Intel[®] Pentium[®] II Xeon[™] Processor Specification Update

Release Date: November 2001

Order Number: 243776-031

The Pentium[®] II Xeon processor may contain design defects or errors known as errata that may cause the product to deviate from published specifications. Current characterized errata are documented in this Specification Update.

Figure 1. An Example of Microcontroller Driven Thermal Management

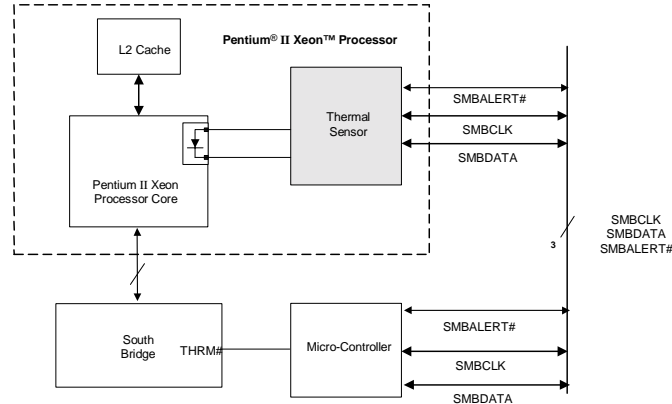
D30. Thermal Sensor May Assert SMBALERT# Incorrectly

Problem: The Pentium II Xeon processor has a thermal sensor that monitors the processor core's temperature. The thermal sensor asserts SMBALERT# if the processor temperature exceeds the temperature limits set in the Alarm Threshold Registers (T_{HIGH} , T_{LOW}). It also sets the corresponding Status Register bits to identify the cause of the interrupt. Figure 1 gives one example of the how the SMBALERT# signal could be used in a system.

Under the conditions described below, the thermal sensor incorrectly generates the SMBALERT# interrupt. *All* of the following conditions must be met to trigger a false interrupt:

Workaround: Three different (mutually exclusive) workarounds are possible:

1. Before servicing an interrupt from the thermal sensor, read and compare the processor thermal reading with the threshold limits (T_{HIGH} or T_{LOW}). Figures 2 and 3 provide basic flowcharts for the implementation of this workaround in an interrupt driven system.
2. If the firmware implemented polls the Status Register only, then before taking any action, re-read the temperature register and do a comparison with the alarm threshold limits (T_{HIGH} or T_{LOW}) to determine if the value is actually still within the temperature window.
3. Use a temperature polling scheme to monitor the processor temperature
